UNITED STATES  
NUCLEAR REGULATORY COMMISSION

SUBJECT: STATUS OF WATTS BAR MOTOR-OPERATED VALVE PROGRAM

STATUS OF WATTS BAR MOTOR-OPERATED VALVE PROGRAM  
(as of June 30, 1995)

MOV issues raised in NRC Inspection Report (IR) No. 50-390/95-21

E				1st ORDER NO.		LIMITORQUE CORPORATION	
D				STOCK SIZE	TRD.	NAME TRIPPER STOP	
C				RGH. WT.		SUPERSEDES:	UNIT. SIZE
B				FIN. WT.		SUPERSEDED BY:	SMB-00
A						DWG. NO. 60-505-0057-1 - 7	
NO.	DESCRIPTION	NAME	C/N NO.	HEAT TREAT			REV. 33
		DATE	APPRD.

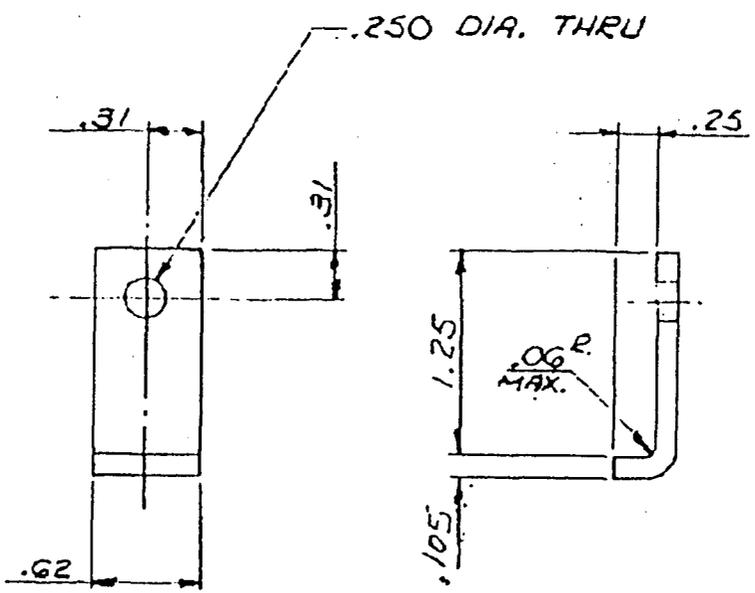
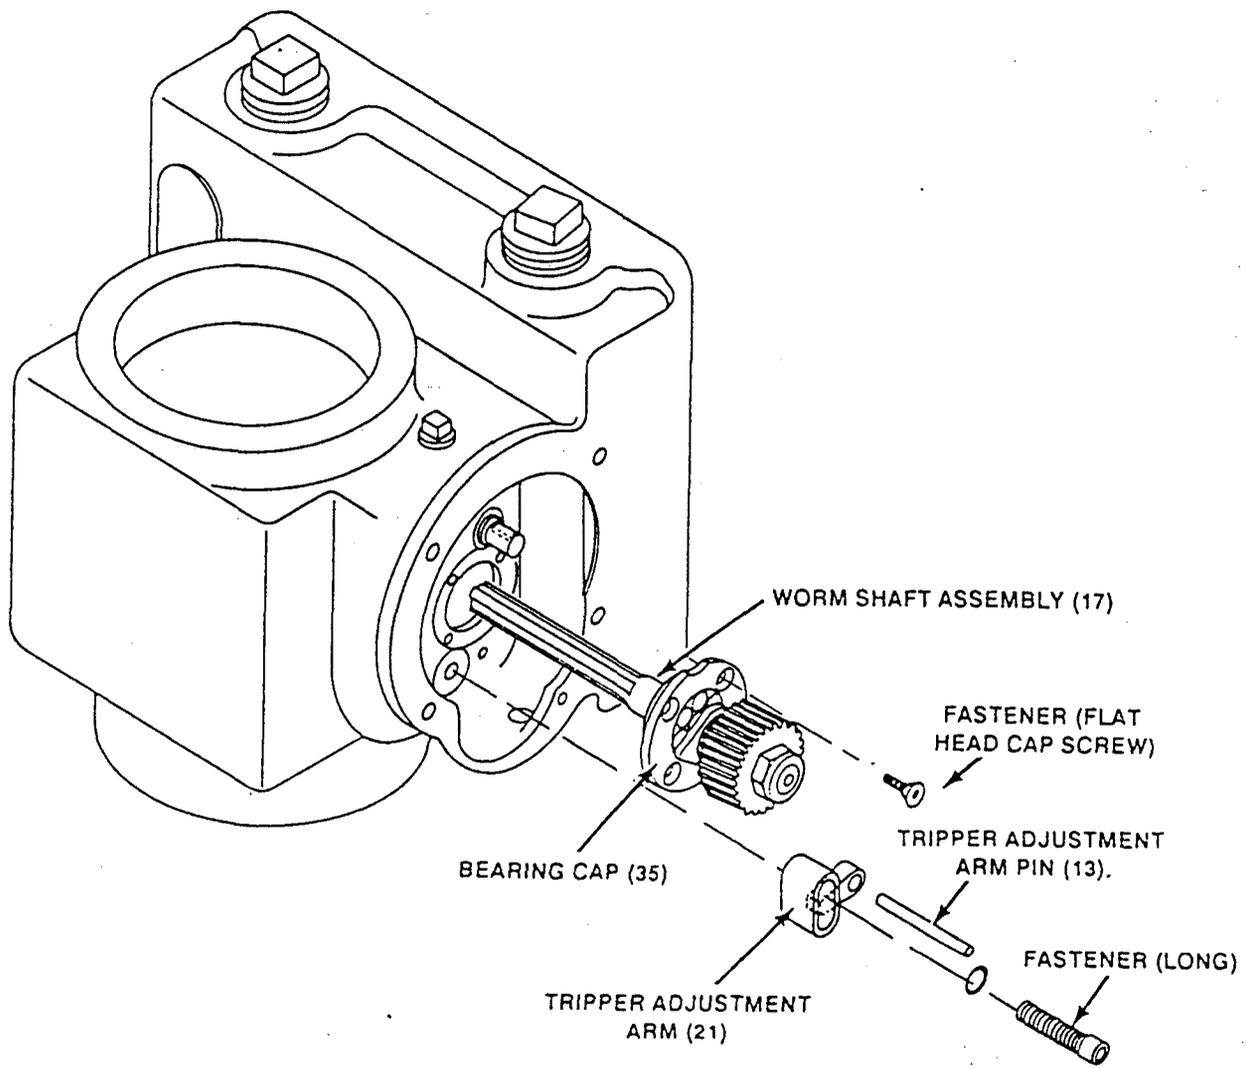
## **Tripper Finger Issue**

PER 950295 written to address the two instances, in process for CAP approval

Limitorque has designed a new part to be installed in the gear cavity to provide a stop for the fingers

Limitorque confirms that electrical operation ensures that the actuator is operational

The applicant has identified a potential problem with the automatic return of certain Limatorque SMB-00 actuators from manual operation to motor operation. In these actuators, the tripper fingers of the manual clutch can catch on the internal edge of the actuator housing. Watts Bar personnel stated that, following the identification of the problem, they learned from Limatorque that this problem could occur on SMB-00 actuators manufactured prior to 1979. Watts Bar personnel stated that Limatorque had indicated that, since 1979, it has performed grinding in the affected area of the SMB-00 actuators to prevent this problem. Watts Bar personnel stated that Limatorque is evaluating the need for a Part 21 notice. The applicant has modified Generic Equipment Operating Guidelines GOI-7 and Maintenance Instruction MI-0.16.02 to require that each MOV be placed in the motor operation mode following any manual operation prior to being returned to service.
